# DE HAVILLAND SERVICE

## TECHNICAL NEWS SHEET

### INDEX series V (Vampire Airframe, General Circulation)

Drawing No. Z.4247.R.Attached hereto.

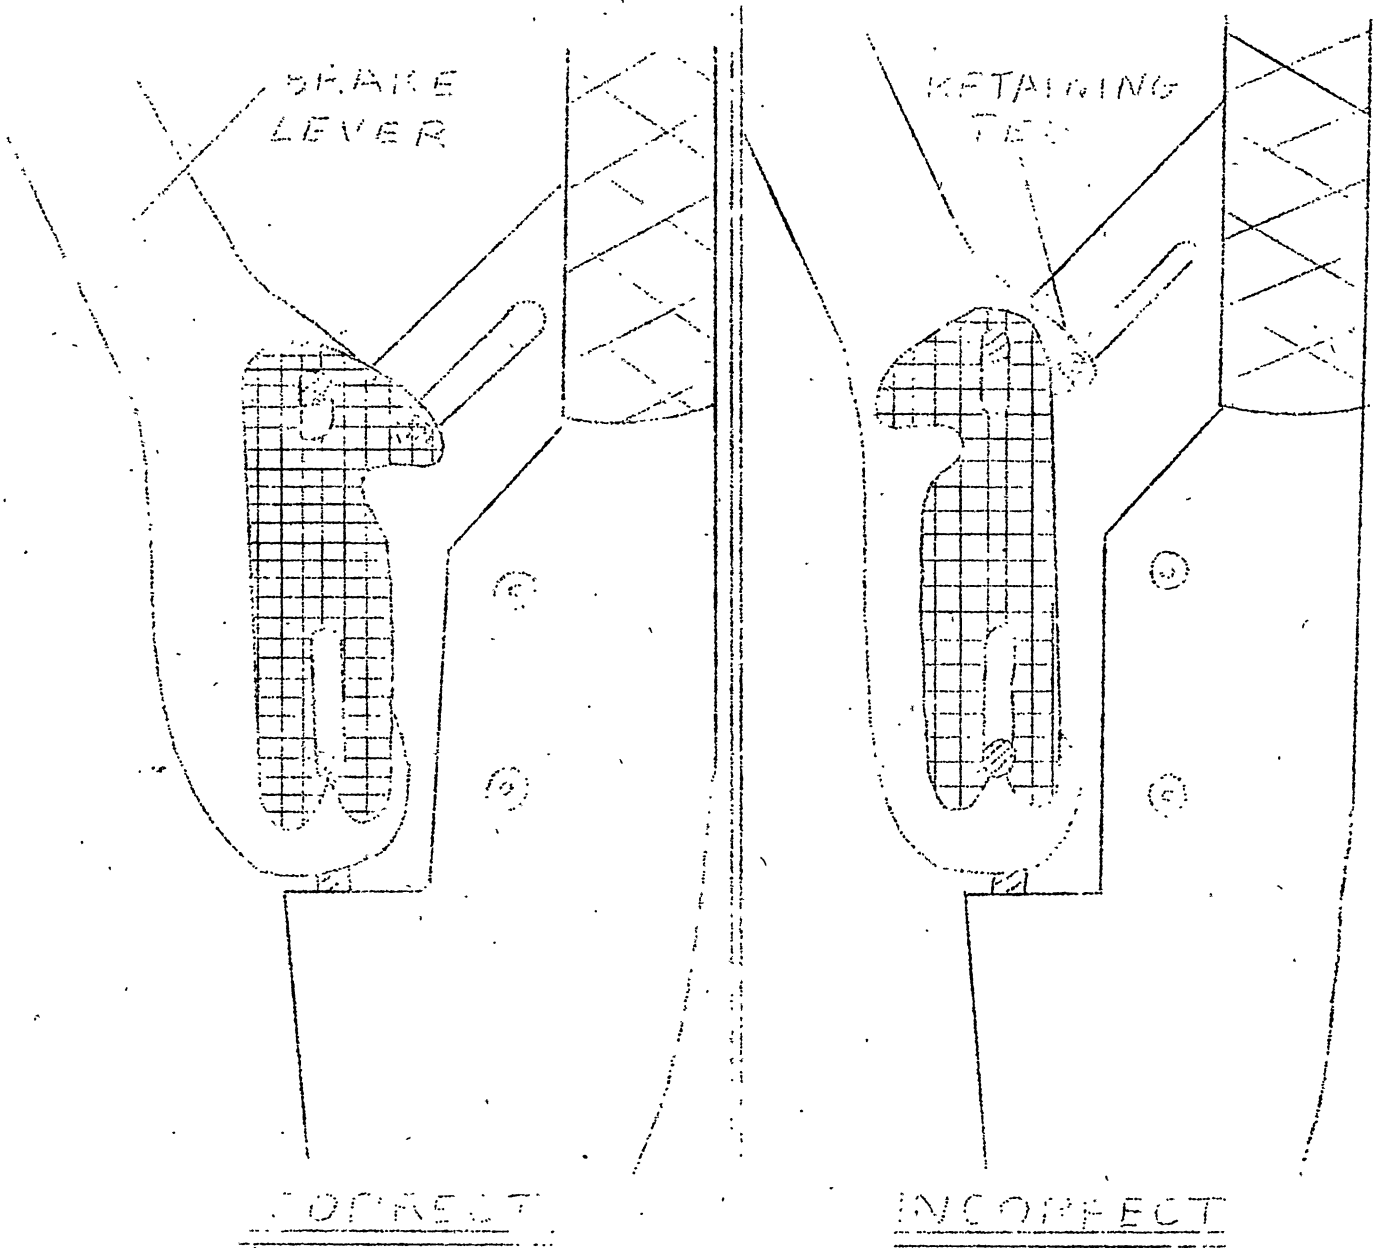
3 The attention of all concerned is to be drawn to the correct method of fitting the retaining clip, as shown in sketch attached, when brake levers are assembled.

D.1. (a) At the first convenient opportunity, and not later than the next primary servicing inspect the spring clip (Part No.AC03118), which secures the brake lever pivot pins and the retaining peg which pivots in the channel of the guide plate, for correct fitment.

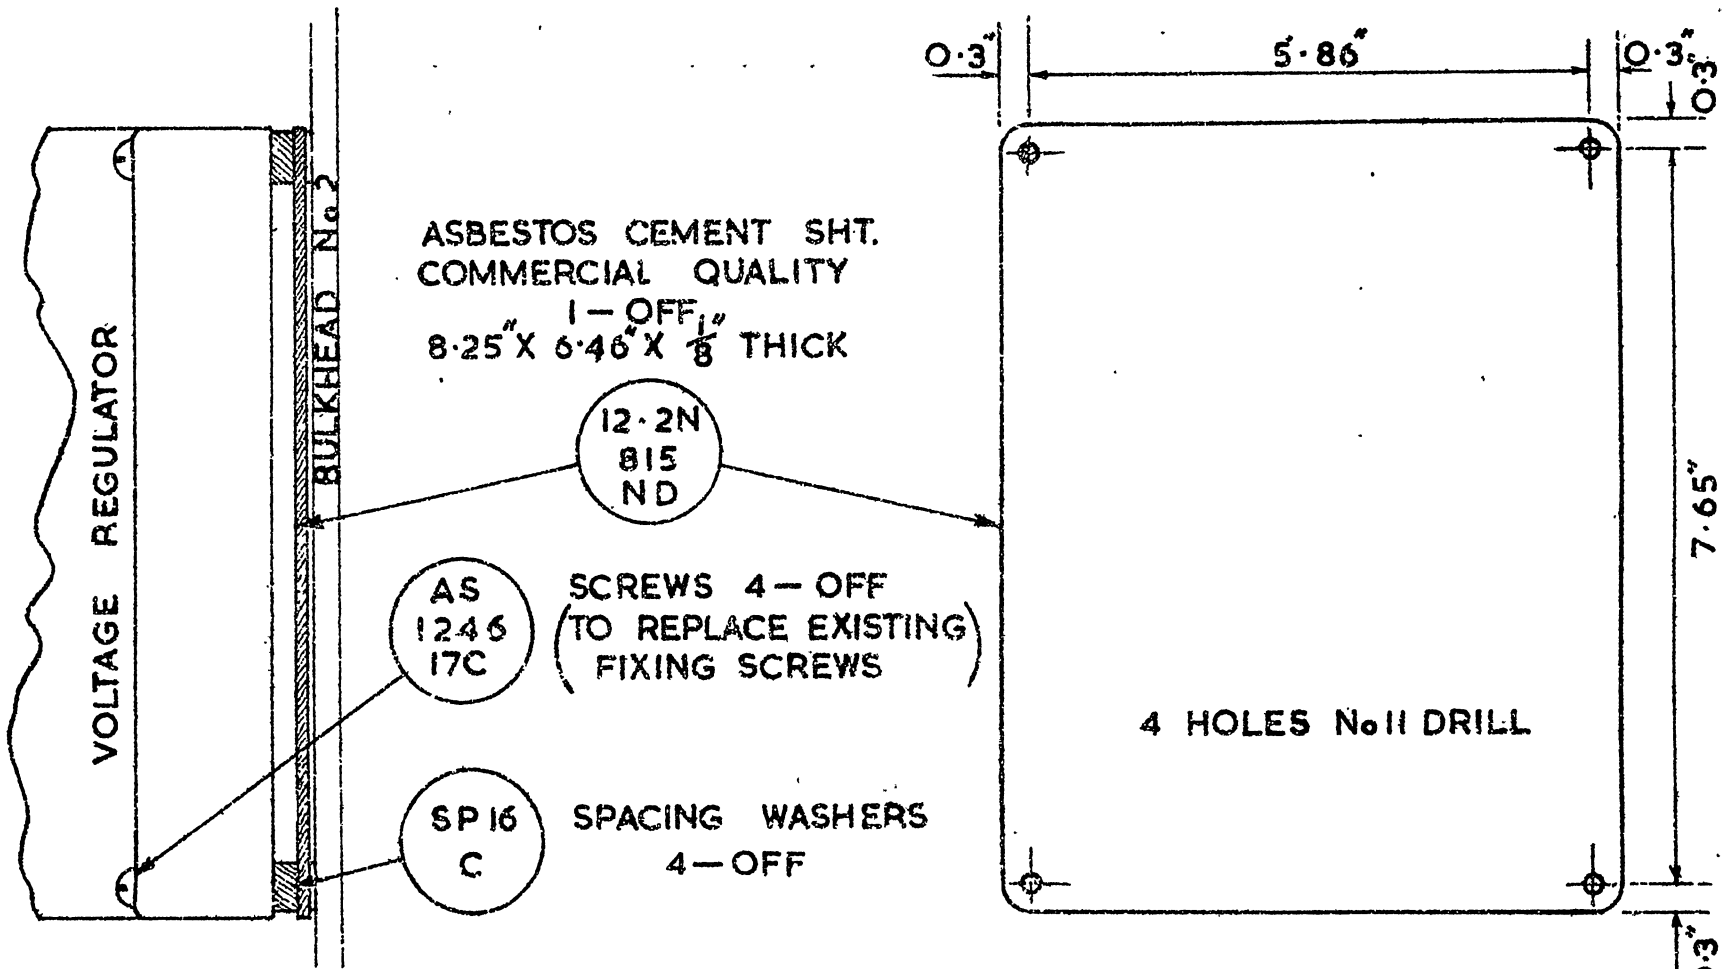
RELEASE REGULATOR FROM BULKHEAD BY REMOVING 4 SCREWS AS/1884/14C & REMOUNT TO BULKHEAD WITH SPACING WASHERS & ASBESTOS SHEET INSERTED BETWEEN, AS SHOWN IN SKETCH, USING SCREWS AS/1246/17C.

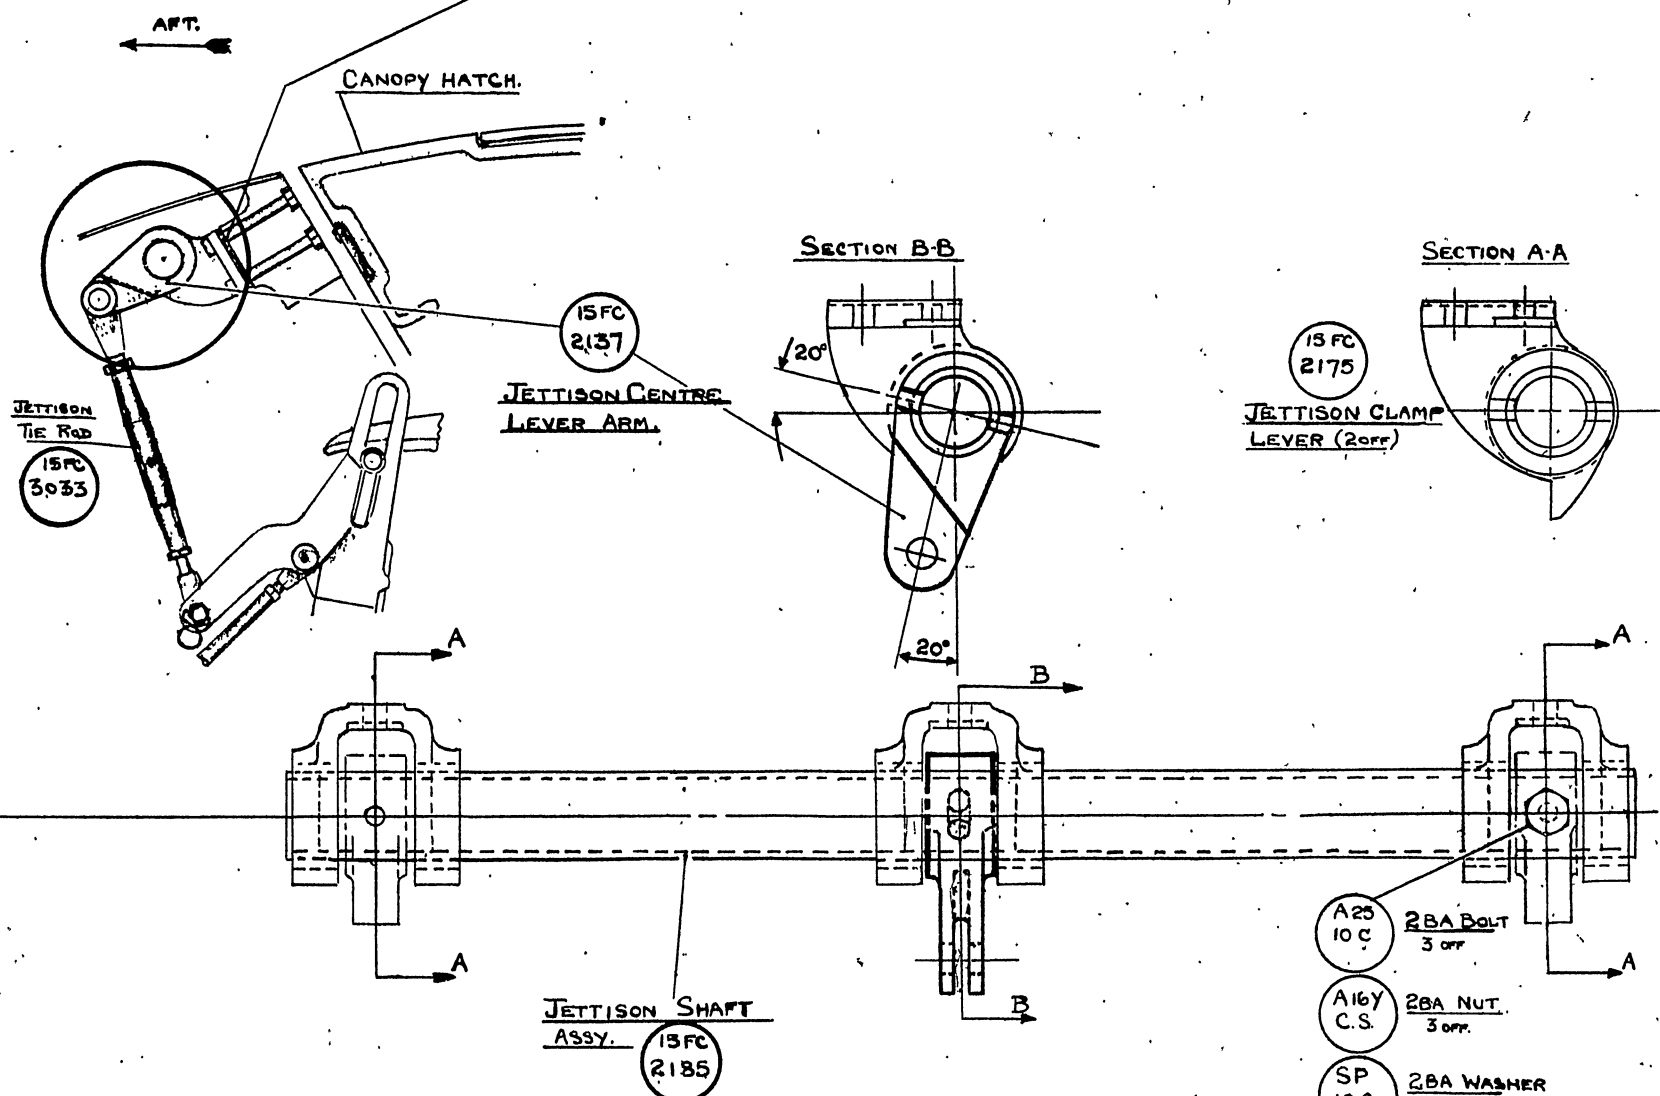
3. Refer to the attached (Drawing R.12.CF.106) and manufacture a fibre block as detailed on the drawing. The 2BA bolt holes are to be counter-sunk on the forward face of the block.

SHIMS .06" NOMINAL THICKNESS LA 3  
 A25 10C 2BA BOLTS 2 off  
 SP 10C WASHERS 2 off  
 A43 2002/C1 STIFFNUT 2 off

- (A25 10C) 2BA BOLT 3 off
- (A16Y C.S.) 2BA NUT 3 off
- (SP 10C) 2BA WASHER 3 off
- (SP9 C 8) SPLIT PIN 3 off
